**Economic and Social Council**Distr.: General  
20 February 2020

**World Forum for Harmonization of Vehicle Regulations****Working Party on Passive Safety****Sixty-seventh session**

**UN Regulation No. 137 (Frontal impact with focus on restraint systems)****Proposal for to the 02 series of amendments of Regulation  
No. 137 (Frontal impact with focus on the restraint system)****Submitted by the experts from Japan and the European Commission on  
behalf of the Task Force\***

**Figure 3**  
**Jointed Test Finger**

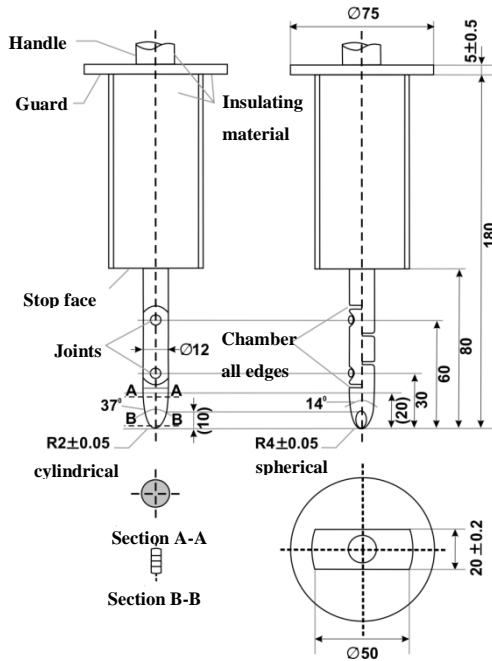
The jointed test finger described in **Figure 31** of ~~Appendix 1~~ shall be inserted into any gaps or openings of the physical protection with a test force of  $10 \text{ N} \pm 10$  per cent for electrical safety assessment. If partial or full penetration into the physical protection by the jointed test finger occurs, the jointed test finger shall be placed in every position as specified below.

The requirements of paragraph 5.2.8.1.3. of this Regulation ~~are shall be considered to be~~ met if the jointed test finger described in Figure 31 of ~~Appendix 1~~, is unable to contact high voltage live parts.

Figure 4  
Example of the Test Method using DC Power Supply

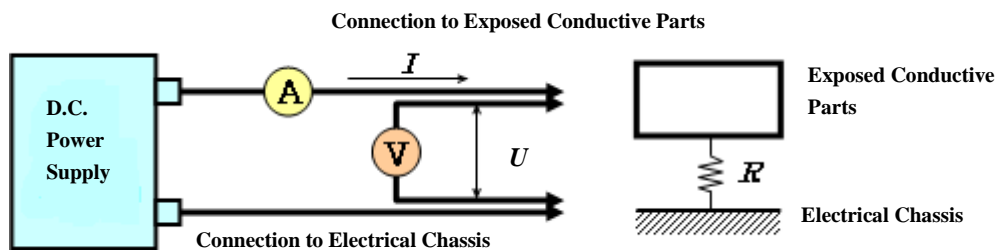
**4.1. Test method for measuring electric resistance:**

- (i) Resistance tester: Measurement current at least 0.2 A;
  - (ii) Resolution: 0.01  $\Omega$  or less;
  - (iii) The resistance R shall be less than 0.1  $\Omega$ .
- (b) Test method using DC power supply, voltmeter and ammeter.

The DC power supply, voltmeter and ammeter are connected to the measuring points (Typically, electrical chassis and electro conductive enclosure/electrical protection barrier).

The voltage of the DC power supply is adjusted so that the current flow becomes at least 0.2 A.

The resistance R shall be less than 0.1  $\Omega$ .

Figure 5  
Measurement of  $U_1'$

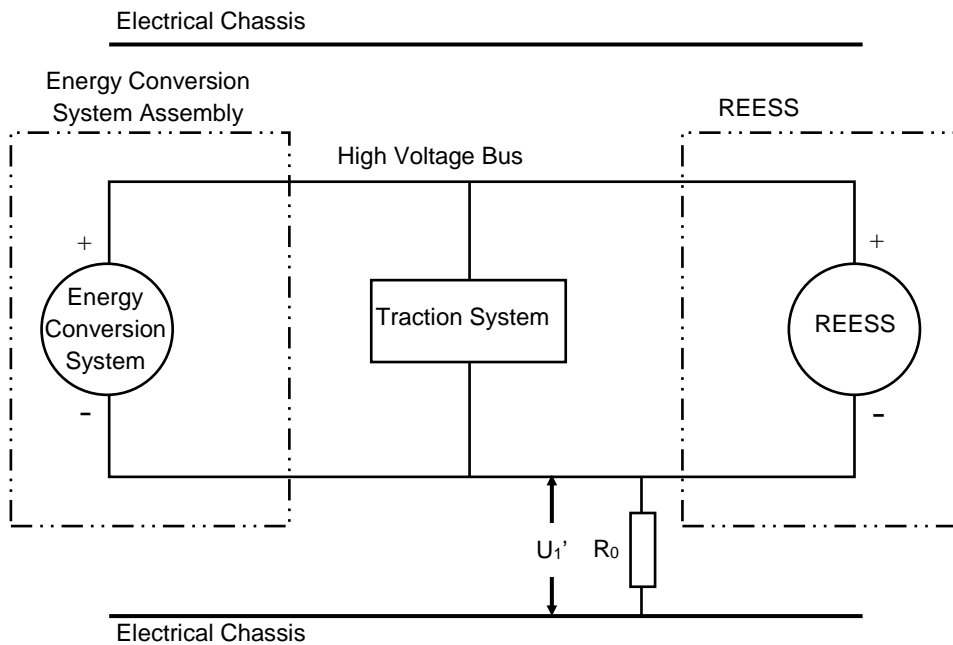
If  $U_1$  is greater than or equal to  $U_2$ , a standard known resistance ( $R_0$ ) is inserted between the negative side of the high voltage bus and the electrical chassis. With  $R_0$  installed, the voltage ( $U_1'$ ) between the negative side of the high voltage bus and the electrical chassis is measured (see Figure 5).

$$R_i = R_0 * U_b * (1/U_1' - 1/U_1)$$

Figure 6  
Measurement of  $U_2'$

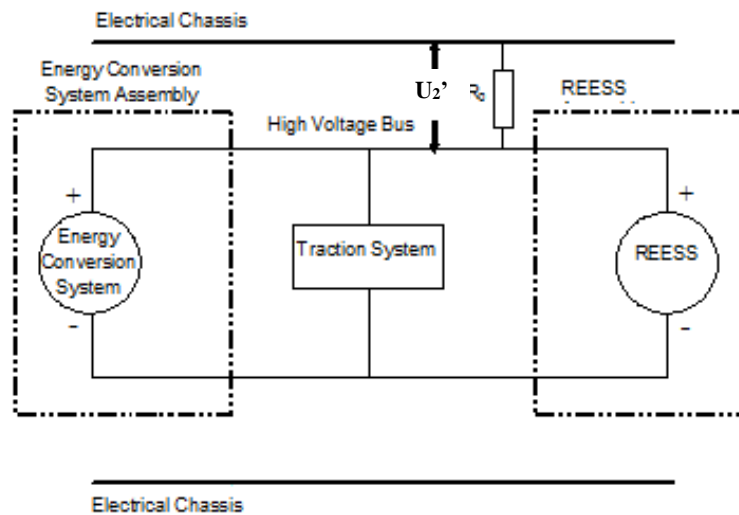
If  $U_2$  is greater than  $U_1$ , insert a standard known resistance ( $R_0$ ) between the positive side of the high voltage bus and the electrical chassis. With  $R_0$  installed, measure the voltage ( $U_2'$ ) between the positive side of the high voltage bus and the electrical chassis (see Figure 6 below). The electrical isolation ( $R_i$ ) is calculated according to the following formula:

$$R_i = R_0 * U_b * (1/U_2' - 1/U_2)$$
